Development Permit No.: D/168-2022

project:
**PROPOSED WORK FOR
71 FOSTER ST, GRACEMERE**

SITE BASED STORMWATER MANAGEMENT PLAN

INFORMATION REQUEST – DEVELOPMENT APPLICATION D/168-2022 FOR A MATERIAL CHANGE OF USE FOR OUTDOOR SALES – SITUATED AT 71 FOSTER STREET, GRACEMERE - LOT 28 ON RP604012

| project: PROPOSED WORK FOR 71 FOSTER ST, GRACEMERE |  Shop 5/10 Denham St Rockhampton QLD, 4700 p 0749 222880 | | title: PROPOSED SITE PLAN | |

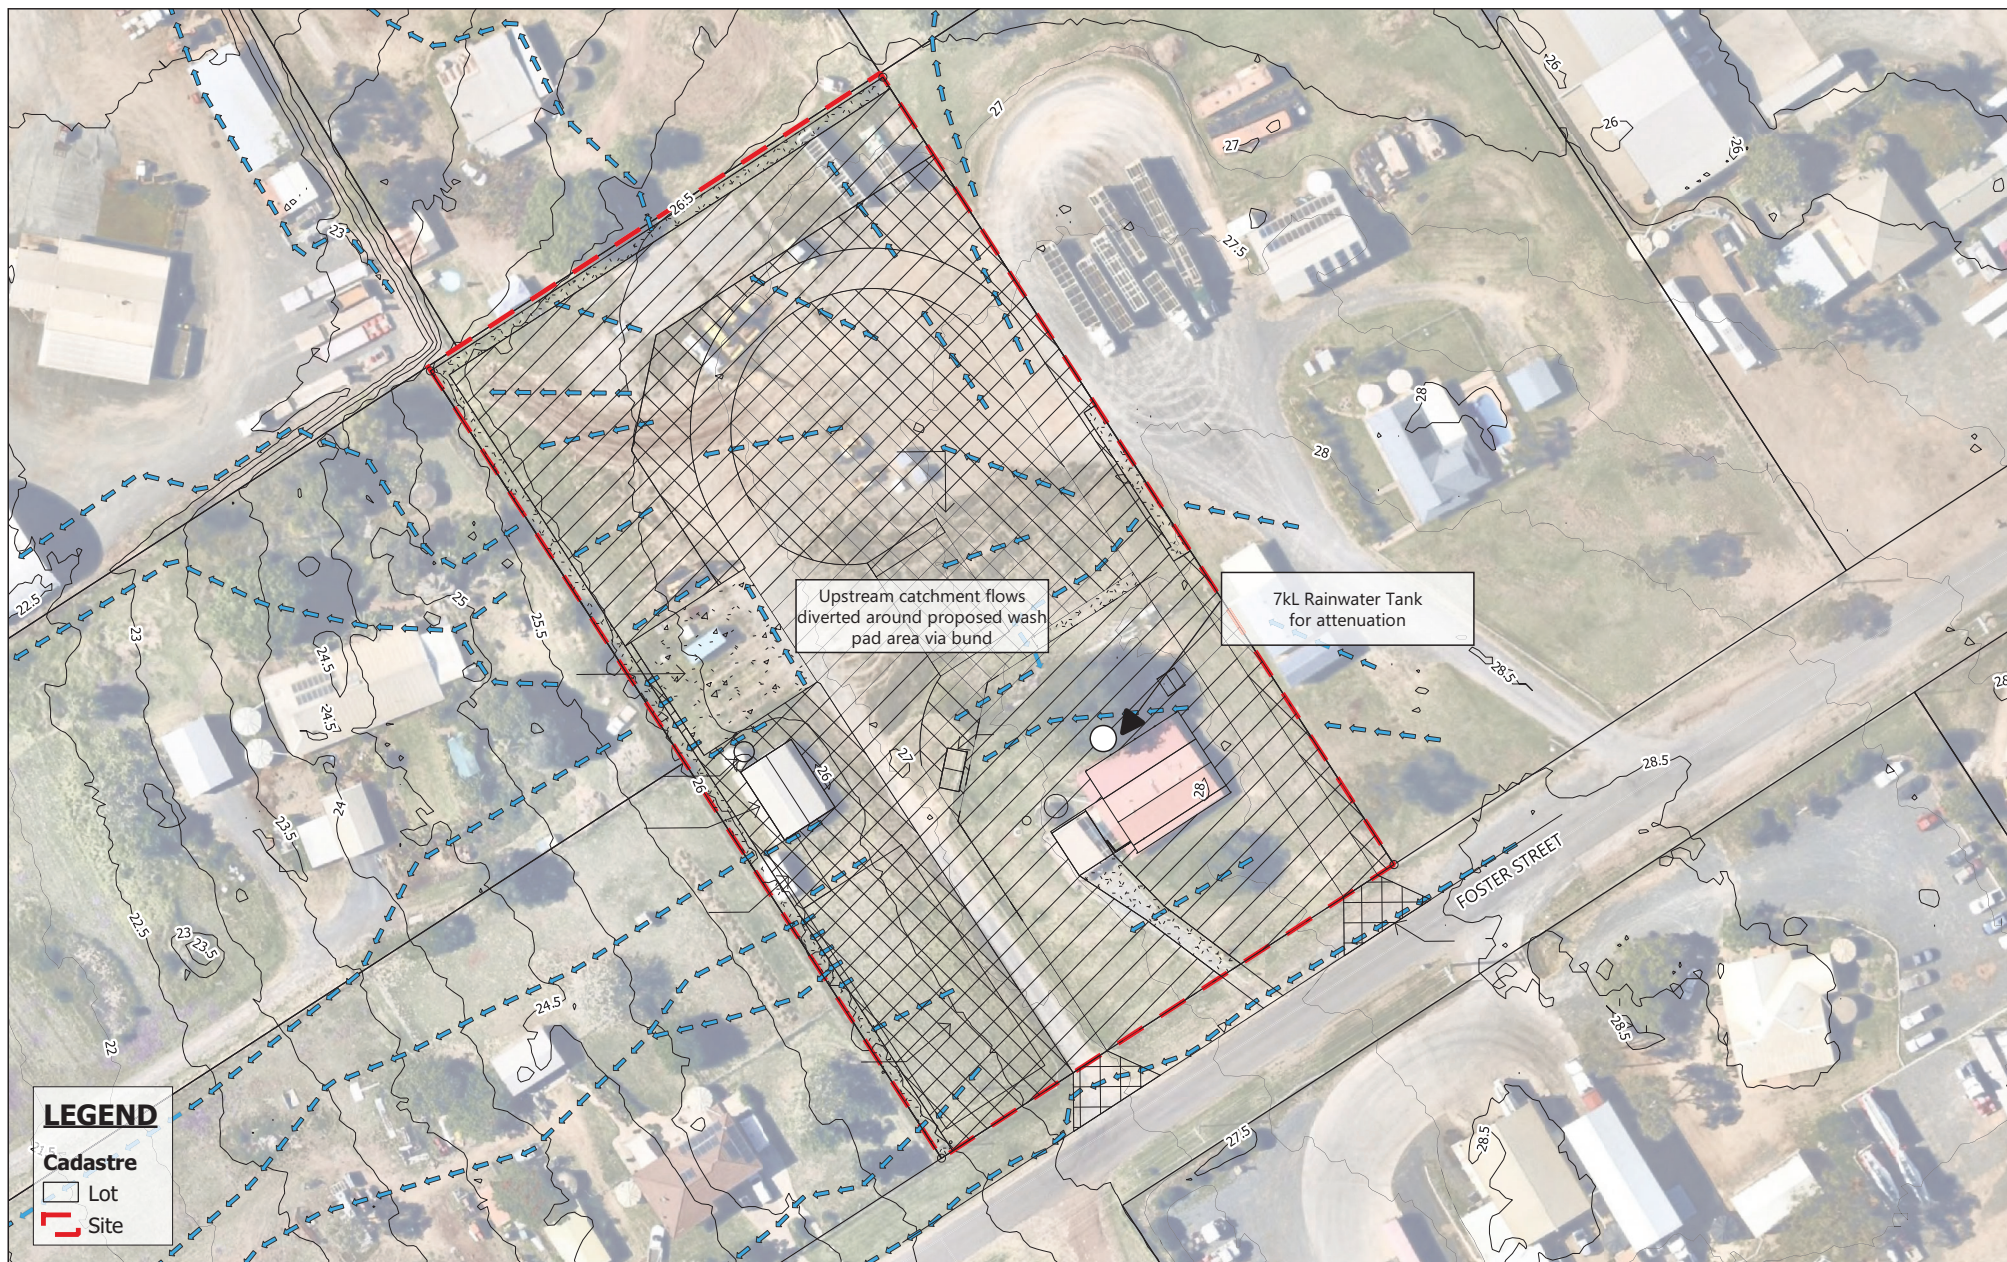
- Mark up carparking areas on site plan to demonstrate compliance with minimum carparking numbers.

- Provide further details on all surface treatment use areas for outdoor sales footprint in square meters which may be displayed as a legend on the plans. I.e. gravel areas, concrete/bitumen hardstand areas onsite.

- Amended plans provided have not dimensioned all buildings and structures onsite. Please provide plans that include all the uses that are dimensioned.

- Provide amended plans that show all setbacks on buildings or structures. Currently the amended plans only include partial setbacks.

- Confirm landscaping dimensions on plan/legend that the proposed landscaping is a minimum width of 2 metres wide.
